Subject: HOPA Addendum # 2 – 605 James Street North, 4th floor Office Renovations

Addendum No. 2

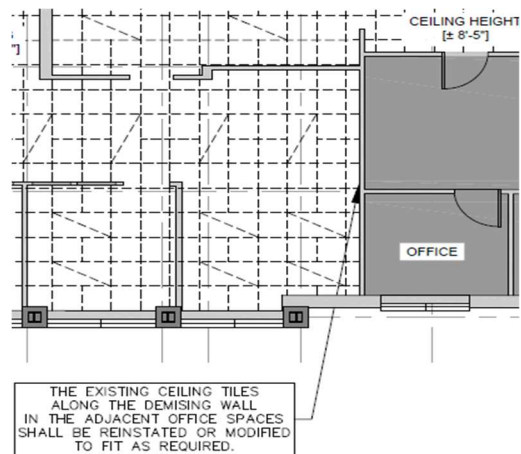
Q24: Referring to the ceiling demolition plan #A201, it indicates that the existing ACT pattern continues. Could you please confirm whether the existing partitions are installed up to the ceiling level, or if this is a drawing mistake?

A24: The existing ceiling tiles continue into the adjacent office space at the location indicated below:

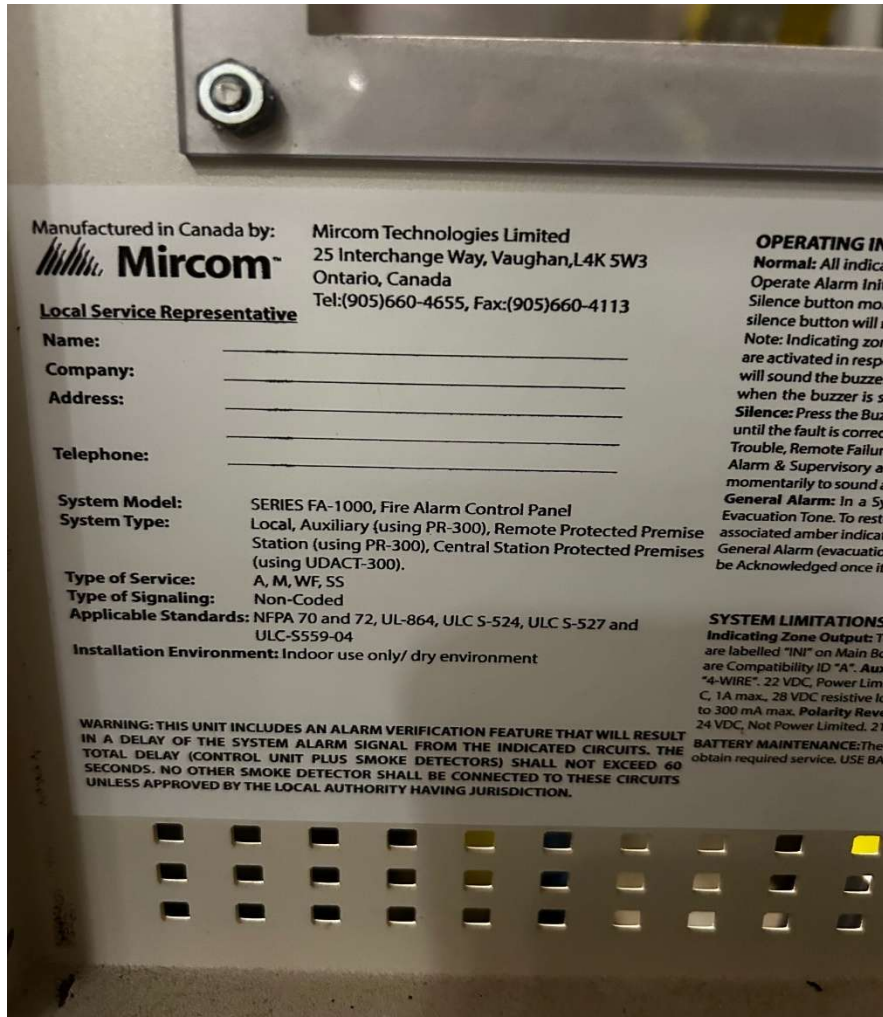
Q44: 1. Please confirm who is handling the Fire Alarm work and who the base building fire alarm company is as well as the info and model of the fire alarm panel.

A44: 1. Refer to answer in Q3 (Addendum No.1) and Q28.

Fire alarm panel photo:
